PCI-SIG ENGINEERING CHANGE NOTICE

TITLE:	PCI Express Capability Structure Expansion
DATE:	21 March 2005, updated 3 November 2005
AFFECTED DOCUMENT:	PCI Express Base Specification Revision 1.1
SPONSOR:	David Harriman, Intel Corporation

Figure 7-9: PCI Express Capability Structure

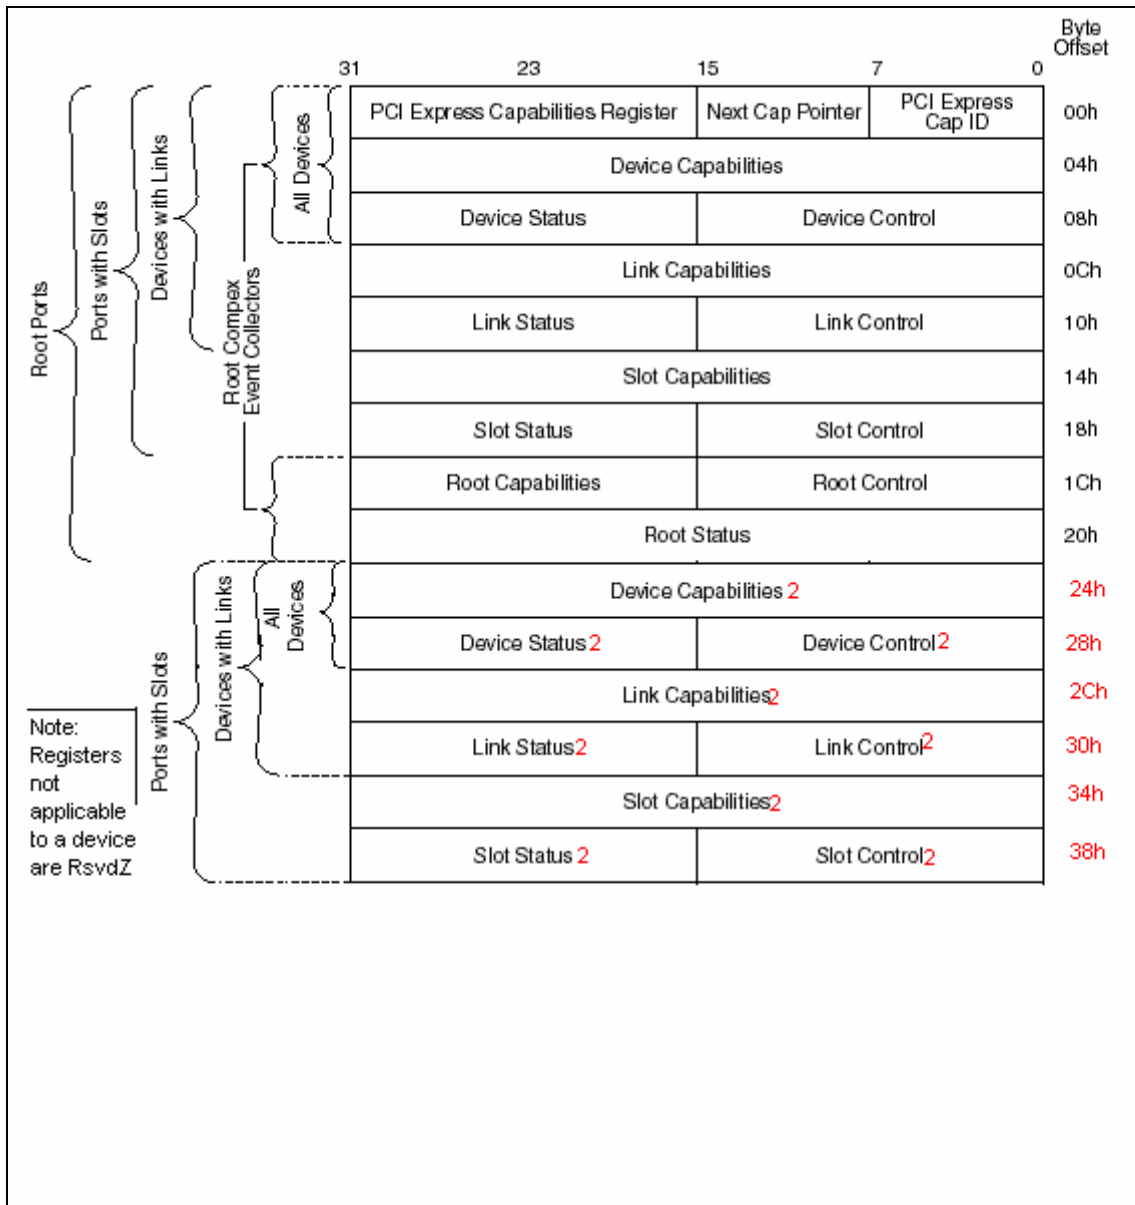
Figure 7-9 details allocation of register fields in the PCI Express Capability structure.

The PCI Express Capabilities, Device Capabilities, ~~and Device Status~~ and Control registers are required for all PCI Express devices. Device Capabilities 2, Status 2 and Control 2 registers are required for all PCI Express devices that implement capabilities requiring those registers. For devices that do not implement the Device Capabilities 2, Status 2, and Control 2 registers, these spaces must be hardwired to 0.

The Link Capabilities, ~~and Link Status~~ and Control registers are required for all Root Ports, Switch Ports, Bridges, and Endpoints that are not Root Complex Integrated Endpoints. For devices that do not implement the Link Capabilities, Status and Control registers, these spaces must be hardwired to 0. Link Capabilities 2, Status 2 and Control 2 registers are required for all Root Ports, Switch Ports, Bridges, and Endpoints (except for Root Complex Integrated Endpoints) that implement capabilities requiring those registers. For devices that do not implement the Link Capabilities 2, Status 2 and Control 2 registers, these spaces must be hardwired to 0. ~~Endpoints are not required to implement registers other than those listed above and terminate the capability structure.~~

Slot Capabilities, Status and Control registers are required for Switch Downstream and Root Ports if a slot is implemented on the Port (indicated by the Slot Implemented bit in the PCI Express Capabilities Register). For devices that do not implement the Slot Capabilities, Status and Control registers, these spaces must be hardwired to 0. Slot Capabilities 2, Status 2 and Control 2 registers are required for Switch Downstream and Root Ports if a slot is implemented on the Port and the device implements capabilities requiring those registers. For devices that do not implement the Slot Capabilities 2, Status 2, and Control 2 registers, these spaces must be hardwired to 0.

Root Ports and Root Complex Event Collectors must implement the Root Capabilities, Status and Control registers. ~~in addition to PCI Express Capabilities, Device Capabilities and Device Status/Control registers~~ For devices that do not implement the Root Capabilities, Status and Control registers, these spaces must be hardwired to 0.

~~Root Control/Status registers are required for Root Ports. Root Ports must implement the entire PCI Express Capability structure. Slot Capabilities and Slot Status/Control registers are required for Switch Downstream and Root Ports if a slot is implemented on the Port~~
